Official Transcript of Proceedings
NUCLEAR REGULATORY COMMISSION

Title: Advisory Committee on Reactor Safeguards
Plant License Renewal Subcommittee

Date: Wednesday, September 19, 2012

CHAIRMAN SIEBER: Good morning. The meeting will now come to order. This is a meeting of the Davis-Besse Nuclear Power Station Plant License Renewal Subcommittee.

Shield Building (cont.)

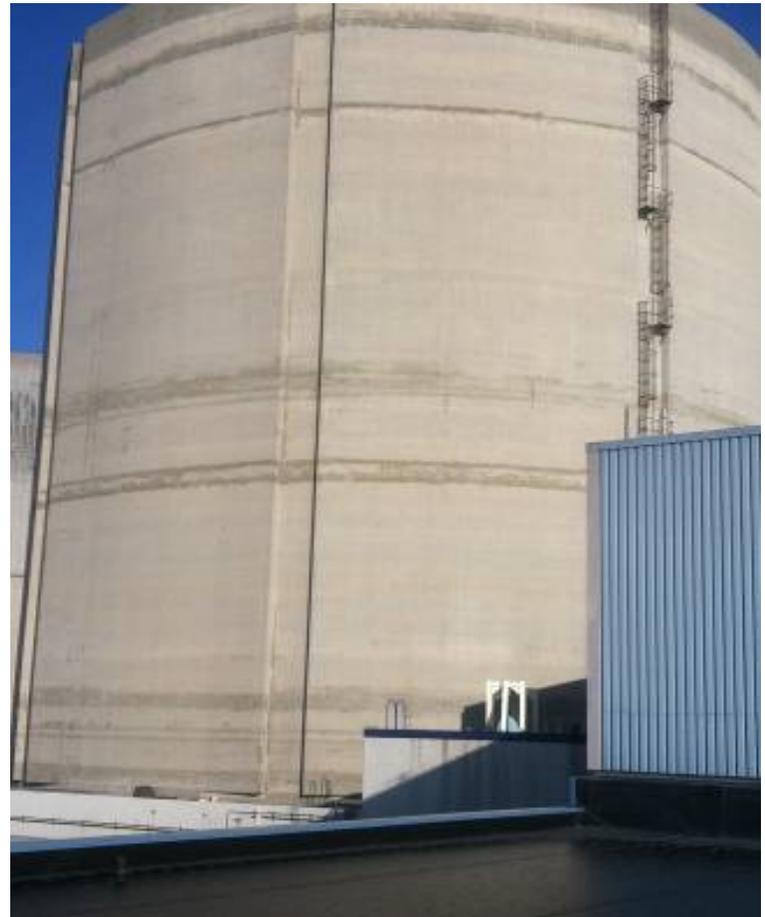
11 MEMBER SHACK: While you're here, could you
12 just show me the geometry of the sand pocket?

6 MR. HOOK: Right, so when you look on the
7 drawing there, the bottom portion of the containment
8 vessel is encased in concrete on the top and on the bottom
9 of it.

20 The water that you found in the annulus is
21 groundwater, is that correct?

11 The sand pocket, I just want to clarify, we call
12 it the sand pocket because at one time there was sand
13 in it, but the sand has been removed. But we still call
14 it the sand pocket area.

19 MR. HOOK: We did extensive investigation
20 in 2002. We did UT readings back then and all the UT
21 readings were greater than the minimum thickness
22 required. And we've done -- like I said, we've done
23 inspections every refueling outage and there's no
24 significant change from 2002.

22 MR. BYRD: That is not correct. There
23 actually is a waterproof membrane on the shield building
24 below grade. There is not a waterproof membrane on it
25 above grade. It was constructed with a waterproof --

Summary of Shield Building Condition (cont.)

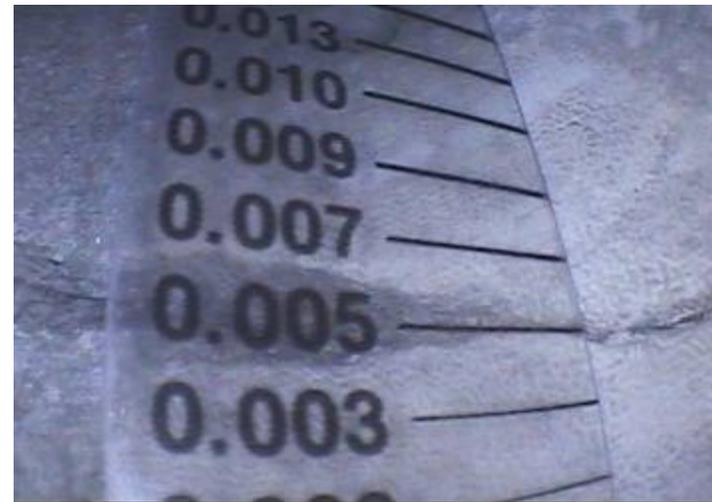
18 Okay. Moving onto the next slide, so we
19 also identified that we had some cracks in the top 20
20 feet of the shield building outside of the flute shoulder
21 region. The way it appeared is it appeared
22 -- and this is in -- and I'll -- this will be more obvious
23 when I show you the map of the total cracking, the cracks
24 had spilled out of the shoulders in the top 20 feet.
25 And then we found two small regions; and these were

1 adjacent to the main steamline penetration block-outs
2 where we also found similar cracking. Now the main
3 steamline penetration block-outs are actually the areas
4 that are right adjacent; and again, the drawing will
5 show that more clearly -- are adjacent to the regions
6 where -- and in the shoulders.

- **Cracking exists at the top 20 feet of the Shield Building wall outside the flute shoulder region**
- **Two small regions adjacent to the Main Steam Line penetration have similar cracks**
 - The extent of these regions is localized and unique to these particular penetrations
- **Cracks are very tight**

Moisture Intrusion and Low Temperatures (cont.)

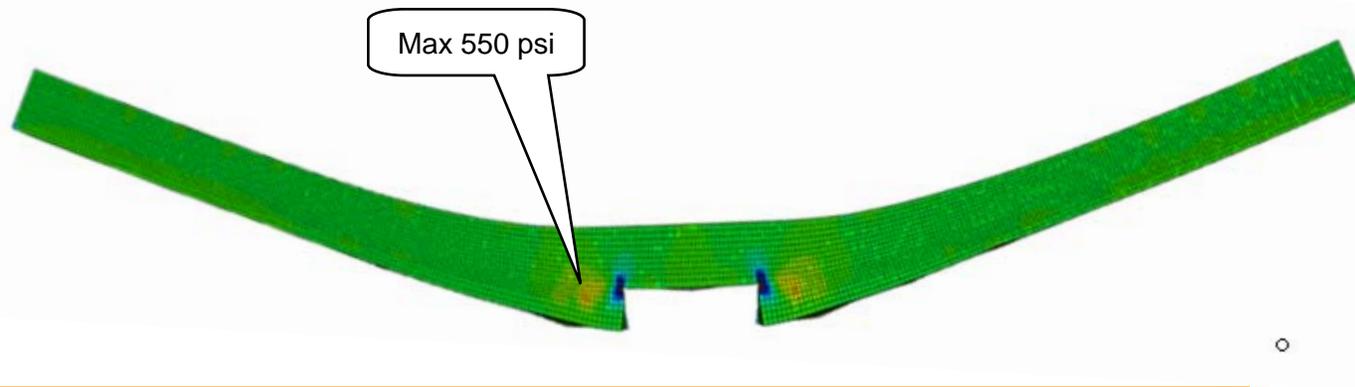
17 MEMBER ARMIJO: That southern exposure
18 argument sure doesn't really tell me much, because
19 that's a big storm. The whole plant's affected.
20 Moisture's -- I'm sure it didn't rain just on one side
21 of the building.

18 MEMBER ARMIJO: You know, the argument
19 -- I'm just -- I'm skeptical about the moisture and
20 freezing part of your root cause. The thermal analysis
21 surprised me, that that didn't provide sufficient
22 stress. Just -- it's a -- looks like a design flaw.
23 Not the shield building integrity, but the flute
24 attachments. You know, I think -- and if it isn't
25 related to moisture, then painting isn't going to do

22 But I was -- My question is do you actually
23 -- did you do measurements of the expansion of
24 water-saturated concrete as it freezes, or is this some
25 model, or you just put in enough expansion to get

19 So with the water crystallization-induced expansion,
20 it's lot more severe than thermal. You can imagine if
21 the thermal is -- in Arizona we have so much hot weather,
22 120 degree Fahrenheit, the fluting didn't report an
23 crack. And we just finish another analysis at another
24 power plant in the south that has flute. But you just
25 look at thermal, it not going to have any laminar crack.
